AGENDA SECTION: PUBLIC HEARINGS	ORIGINATING DEPT: PLANNING	ITEM NO. <b>E-11</b>
ITEM DESCRIPTION: Preliminary Plat #02-64 by Bigelow Enterprises to be known as Kingsbury Hills Fourth and Design Modification to eliminate 2 mid-block pedestrian connections and request for a Substantial Land Alteration Permit.		PREPARED BY: Mitzi A. Baker, Senior Planner

KINGSBURY HILLS FOURTH

**RE: Preliminary Plat # 02-64 to be known as Kingsbury Hills Fourth, by Bigelow & Sons Enterprises. The plat contains 61.81 acres to be subdivided into 200 single-family home lots and 6 outlots. The plat includes a request for a Design Modification to eliminate 2 mid-block pedestrian connections between the proposed Castlevue Ave. NW & 60<sup>th</sup> Ave. and a Substantial Land Alteration Permit to allow grade changes in excess of 10 feet. The property is located at the SE corner of 55<sup>th</sup> St. NW & 60<sup>th</sup> Ave. NW.**

# DESIGN MODIFICATION

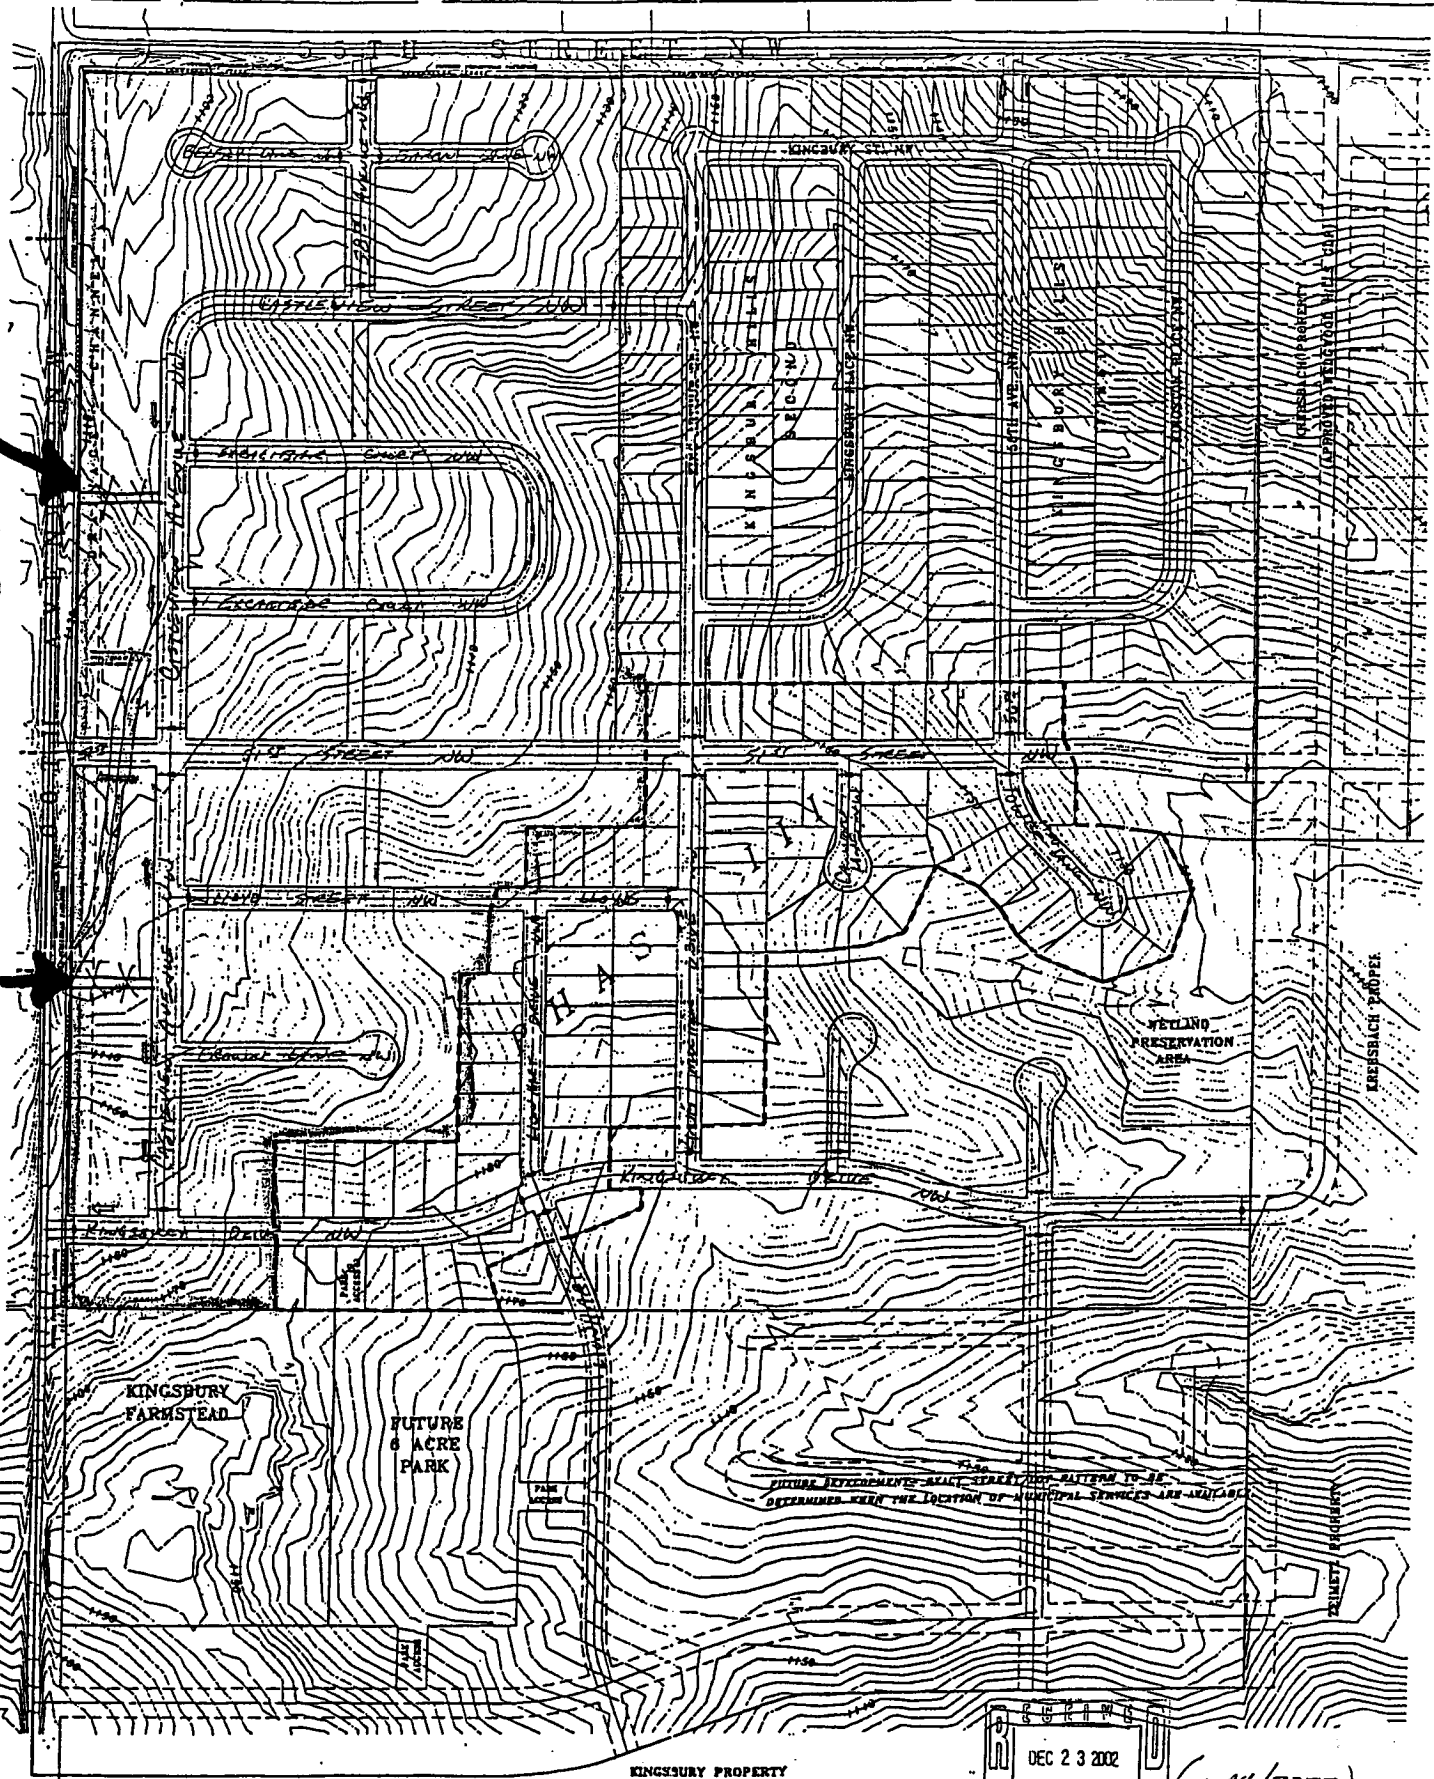
The applicant is requesting a Design Modification (waiver) to two required mid-block pedestrian connections. Both are connections that would provide a pedestrian link between "Castleview Ave. NW" and 60<sup>th</sup> Ave. NW. A primary concern with these two mid-block connections would be topography. They would need to be designed to cross a 50' wide, 4' deep drainage channel.

On behalf of our client, Bigelow Enterprises, we are requesting a design modification to the requirement of two mid-block connections for the Kingsbury Hills Fourth subdivision. Both mid-block connections link Castlevue Avenue NW (proposed) to 60<sup>th</sup> Avenue NW (existing) as are shown on the attached plan.

Rochester Public Works informed Planning staff that they support the design modification as requested. ***Staff recommends approval of the design modification as requested.***

11. Public Works is supportive of the requested design modification to eliminate the pedestrian mid-block connections to 60<sup>th</sup> Ave NW.

# SUBSTANTIAL ' AND ALTERATION

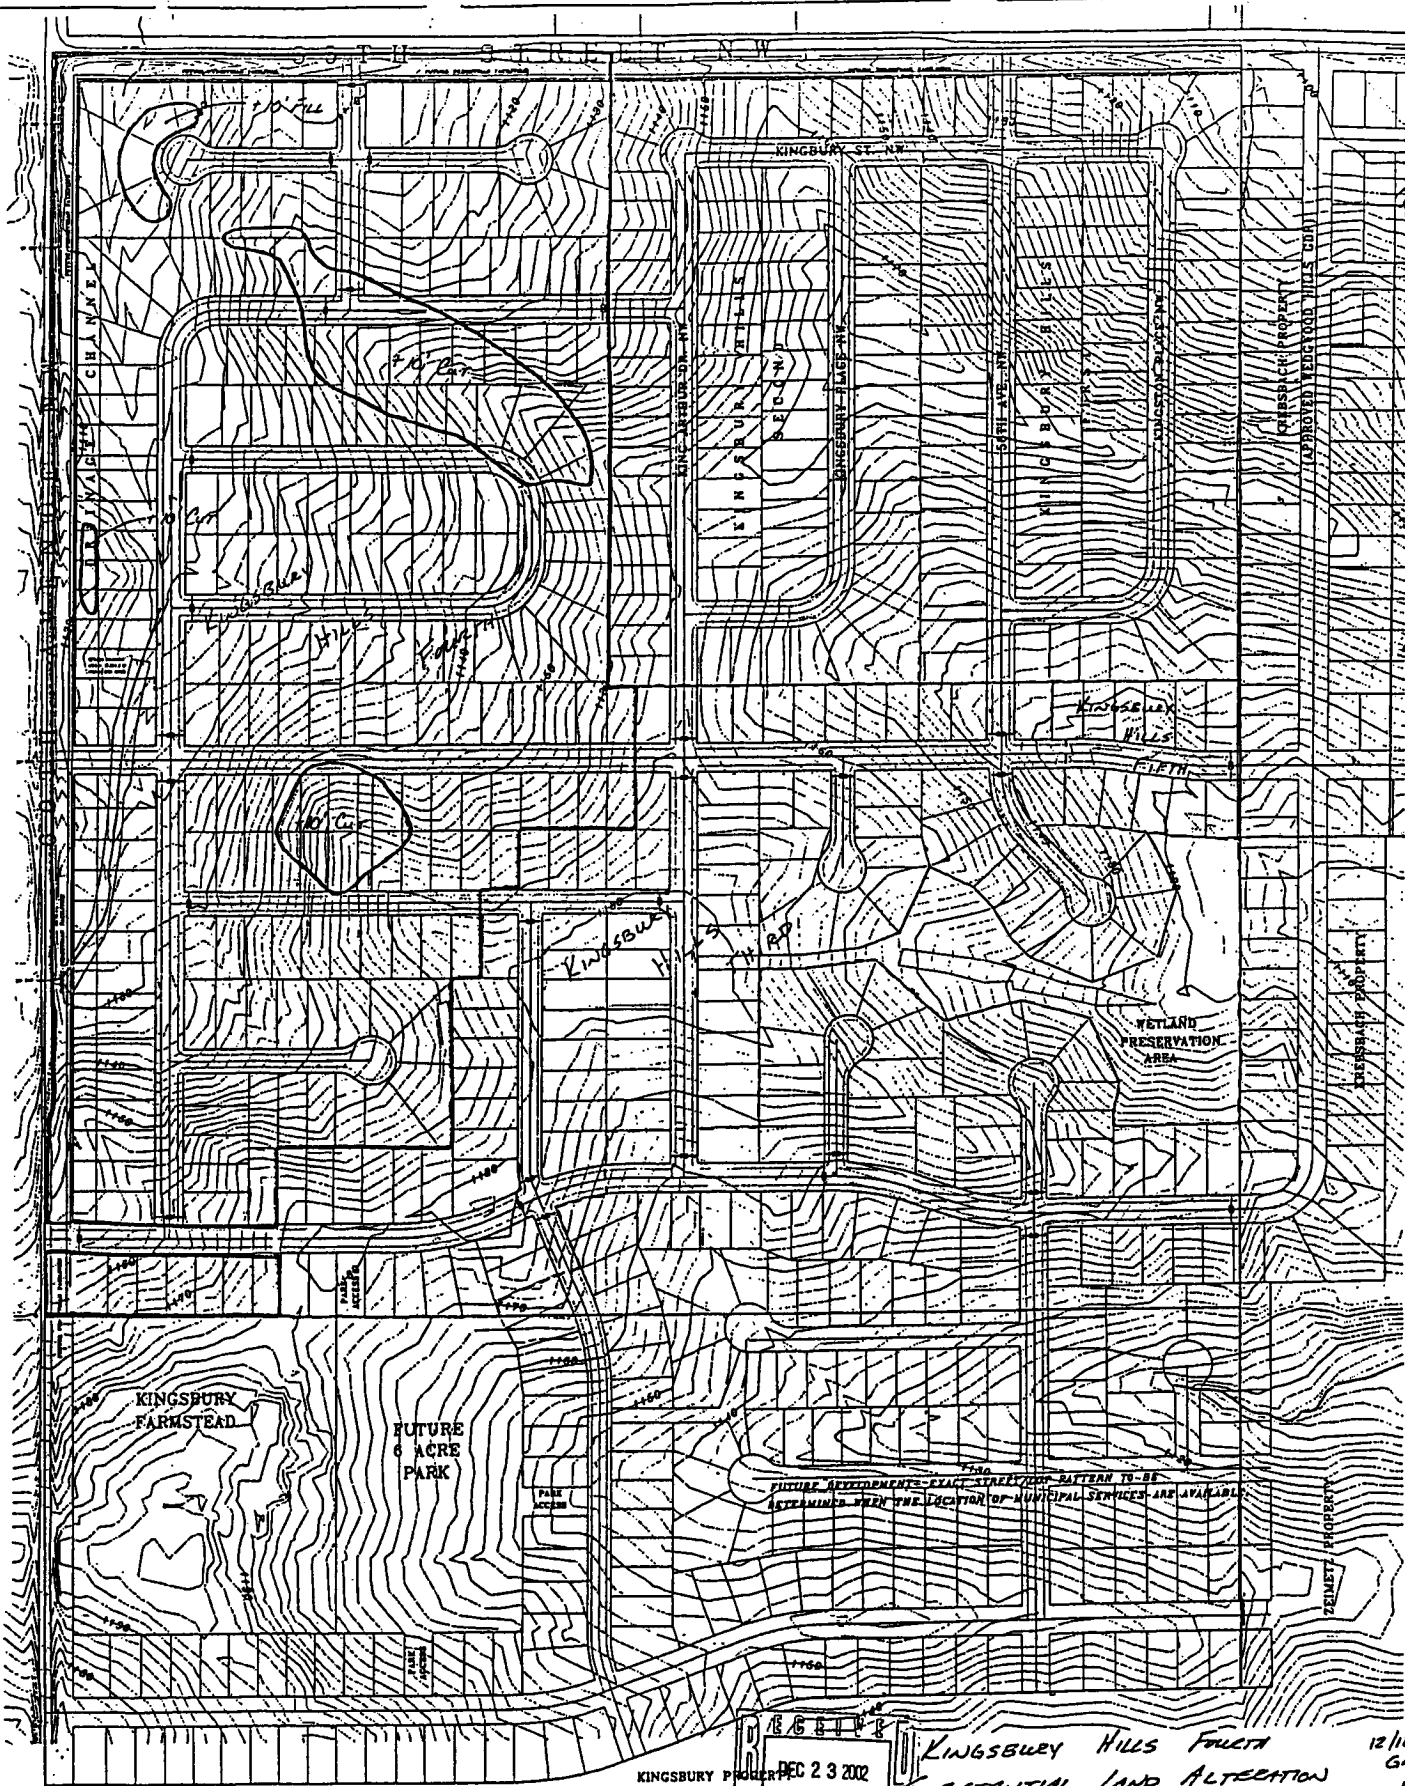
The applicant is requesting approval for grading work that includes altering grades by 10 feet or more in five locations in or adjacent to this Plat. The attached plan identifies four fill and one cut area areas that will exceed 10 feet of grade change. Please see the attached plan and narrative prepared by McGhie & Betts, Inc.

Regarding findings for Section 62.1105, staff suggests the findings as written can be made, with the exception of #13 and #14. Staff suggest the following findings for those two items:

*#13) The grading and drainage plans and erosion and sedimentation control plans must be approved by the City prior to commencement of grading activities on this property.*

*#14) The applicant must provide surety that guarantees that the site will be fully restored, after completion of the excavation activity, to a safe condition, and one that permits reuse of the site in a manner compatible with the Comprehensive plan, neighborhood plans, and Land use Plan and applicable City policies. Said surety must be provided prior to commencement of grading activities on this property.*
